## [16-Gallon Drum Dolly redesign](#)

December 28, 2015 || 16-394

The BG 16-Gallon Drum Dolly, PN 938B, is being redesigned to accommodate new, wider diameter 16-gallon drums.

### **Clips for 2-inch casters**

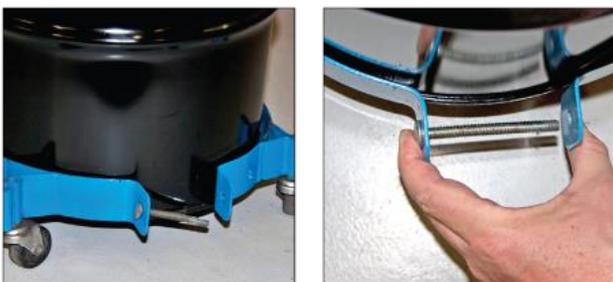
The new 16-gallon black drum is unstable when placed in the 16-Gallon Drum Dolly Base, PN 938B, with 2-inch casters purchased before December of 2008. To remedy this, we've made support clips: Support Clip for Old Style 938B, PN 938B-02. One of these clips should be positioned on each side of the carriage as shown in photo. These clips will be provided as necessary at no charge.

NOTE: Support clips are not necessary for 938Bs with 4-inch casters purchased after December of 2008.
